Report to the Future Melbourne (Planning) Committee

**Ministerial Planning Referral: TPMR-2019-24
102-156 City Road, Southbank**

DELEGATE REPORT

MINISTERIAL PLANNING REFERRAL

Figure 16: Shadow cast over the Australian Centre for Contemporary Art Forecourt at 2pm on 22 April

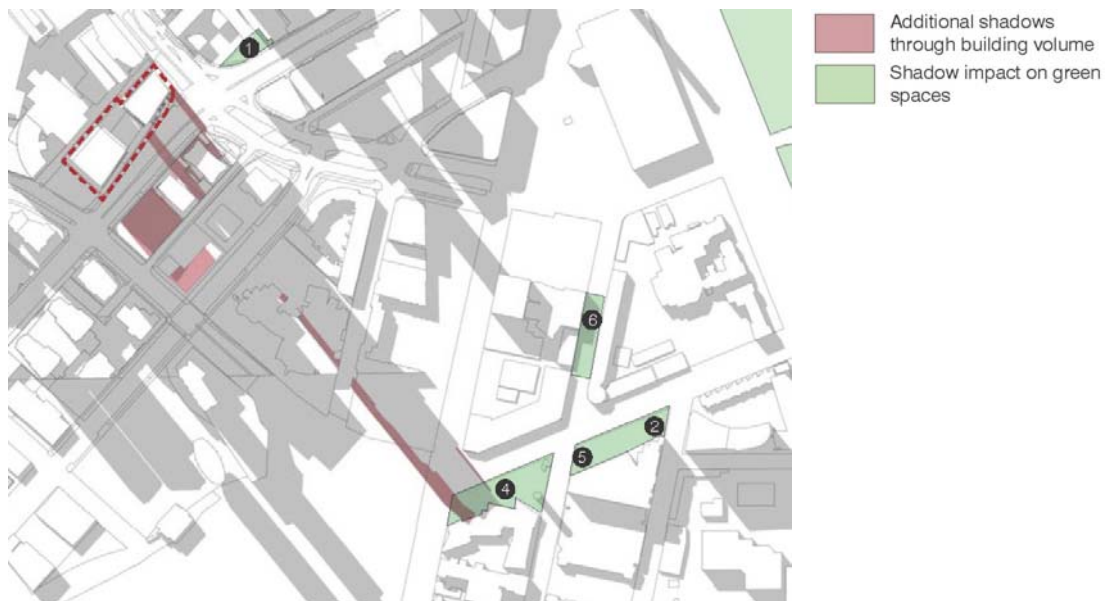
Shadow is cast over the Australian Centre for Contemporary Art Forecourt at 2pm on 22 April – refer Figure 16.

The extent of additional shadow is minimal and inconsequential given the extent of existing shadow already cast over this forecourt and the time of day (i.e. no shadow for the entire day leading up to 2pm). Furthermore, additional studies have been prepared, identifying no shadow cast over this space until 1.55pm. As such, the extent of ‘non-compliance’ is for a total of 5 minutes. The additional shadow will not unreasonably prejudice the amenity of this space and is therefore considered acceptable.
